# ADA Curb Ramp New Construction Inspection Form (Parallel)

Glencoe

24952.54

Cottage

PARALLEL RAMP (PL)

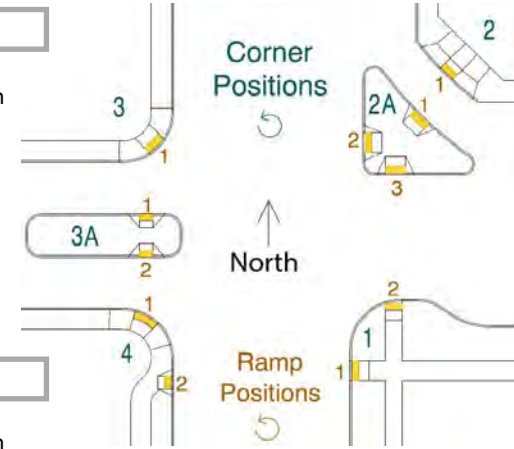
$\leq 2.0\%$  ☐  $> 2.0\%$  ☒

☐   $\leq 8.3\%$  ☐  $> 8.3\%$  ☒

$\leq 2.0\%$  ☐  $> 2.0\%$  ☒

IITD,grater than2" behind curb
